Technical bulletin

**NEW VIDEO SIGNAL
CABLE**

Technical bulletin:

150

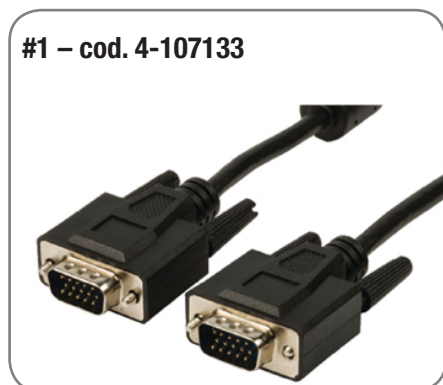
We hereby would like to inform you that, as from May 2021, all touch-screen monitor wheel balancers will be equipped with a new video signal cable, code 4-107133 (#1), replacing the previous code 3-03554 (#2).

The modification provides better protection against electrical interferences generated by inadequately filtered networks and can solve, on some models already installed, the complaint of a brief temporary interruption of the video signal.
